HPC-18-17

SUBJECT: Certificate of Appropriateness for HVAC alterations

LOCATION: 207-211 North Main Street

CULTURAL LISTING: Mechanics / Masonic Building, constructed 1890, HABS number 5PE.556, listed on National Register of Historic Places on June 16, 1983, local landmark designated in September 9, 2002 by ordinance 6888

1 THIRD LEVEL PLAN
A3.3 SCALE 3/16" = 1'-0"

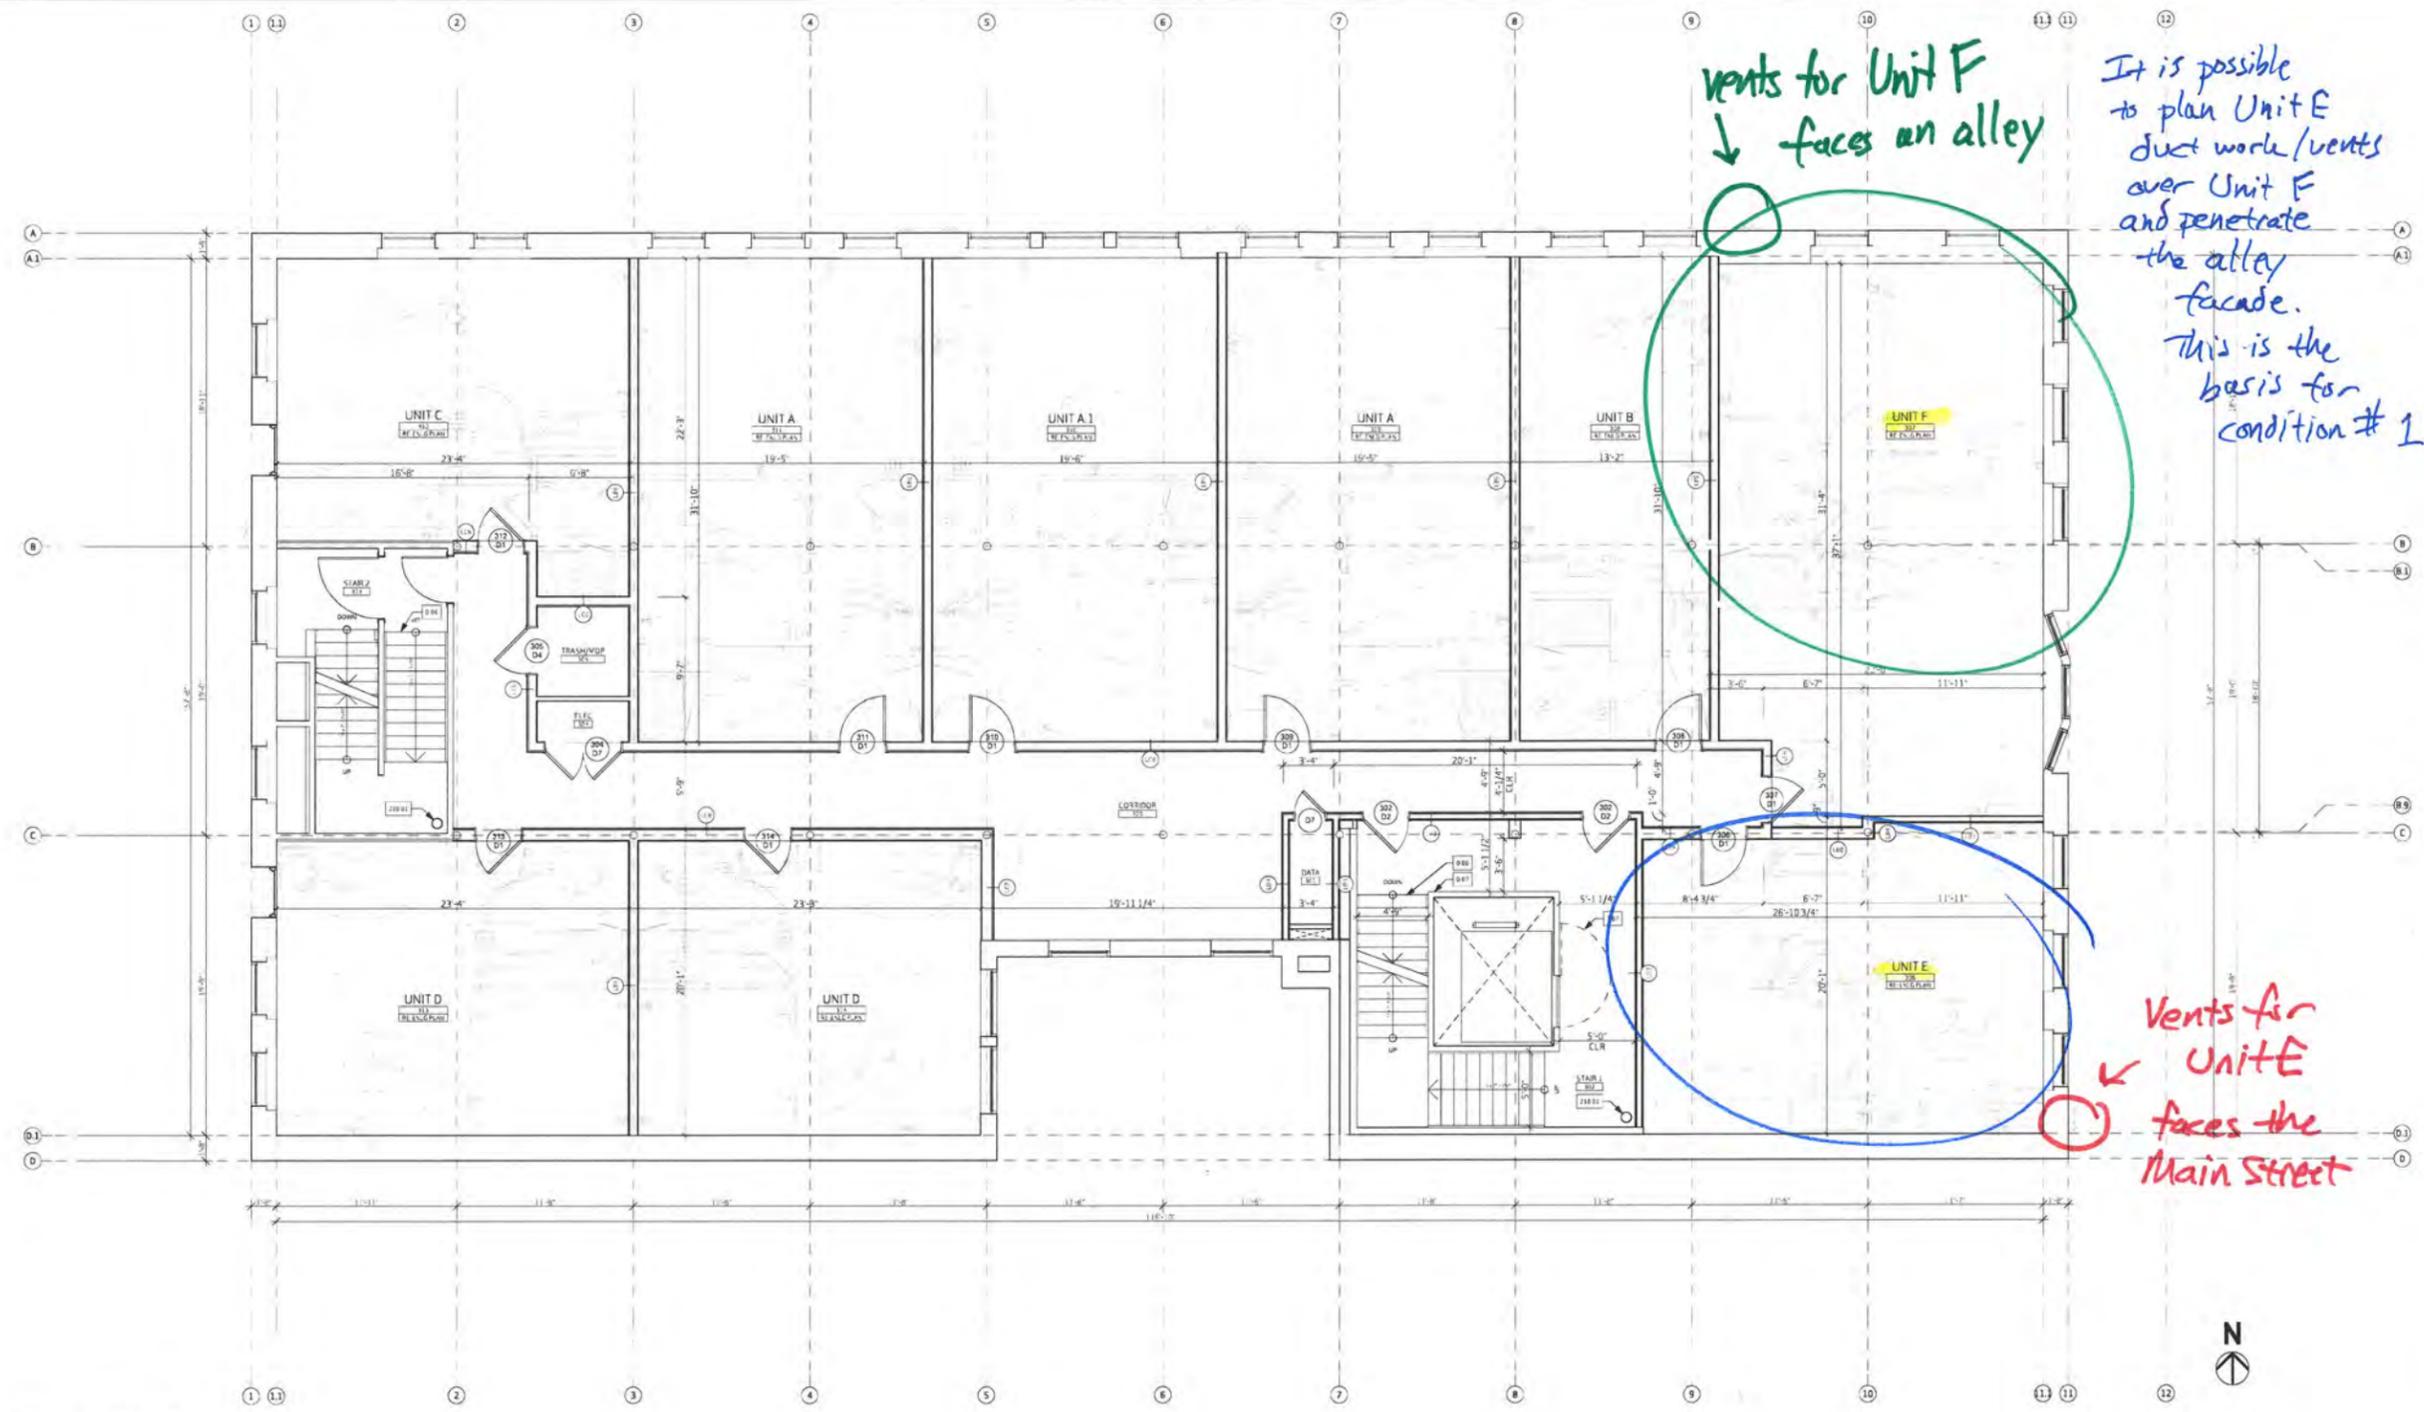
vents for Unit F
↓ faces an alley

It is possible to plan Unit E just work/vents over Unit F and penetrate the alley facade. This is the basis for condition # 1

Vents for Unit E faces the Main Street

This is generally the same for floors 2, 3, and 4.

1. For levels 2, 3, and 4, plan the HVAC ductwork for Unit E so that it is contained in the ducts above Unit F to direct penetration to the side (north elevation) in lieu of the street-facing front (east elevation).
2. Identify existing color scheme (historic palette) and provide specific paint color of vent cover (vendor color in lieu of “paint to match”) for administrative review.
3. Refer to the following Technical Preservation Briefs,⁷ which may be applicable to the overall project:
 - a. #24, Heating, Ventilating, and Cooling Historic Buildings: Problems and Recommended Approaches

1 EAST ELEVATION
N.T.S.

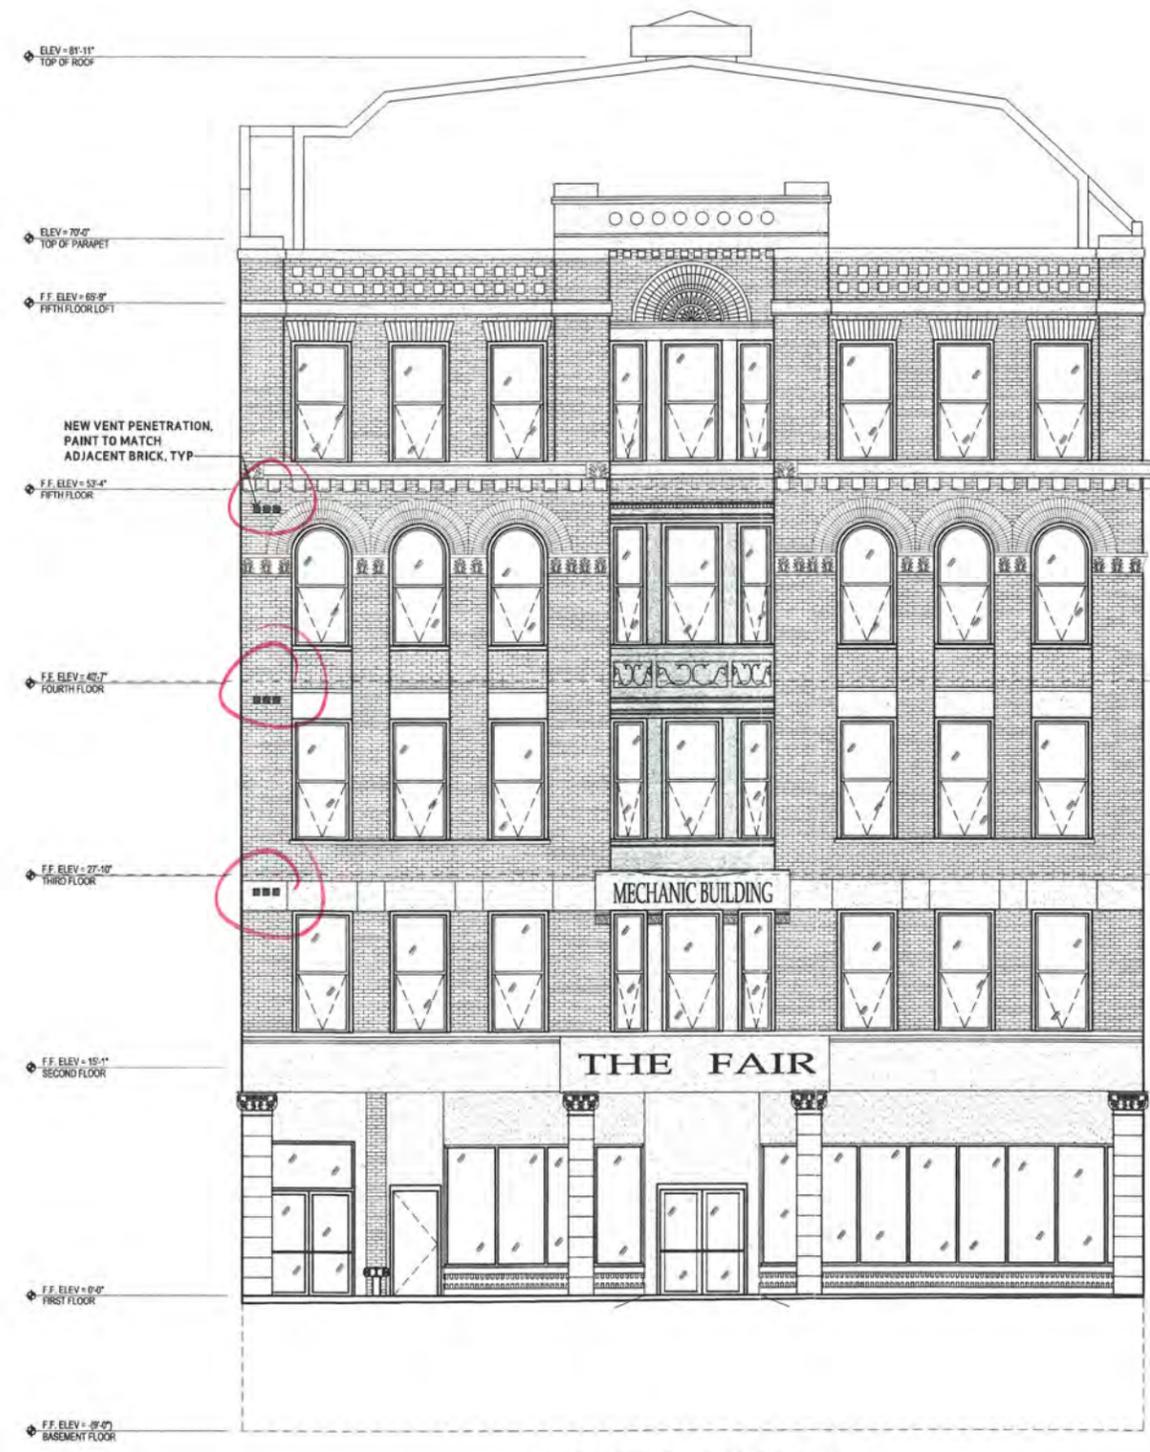
Unit E
only needs
vents on
front facade

each unit
needs 3 vents:
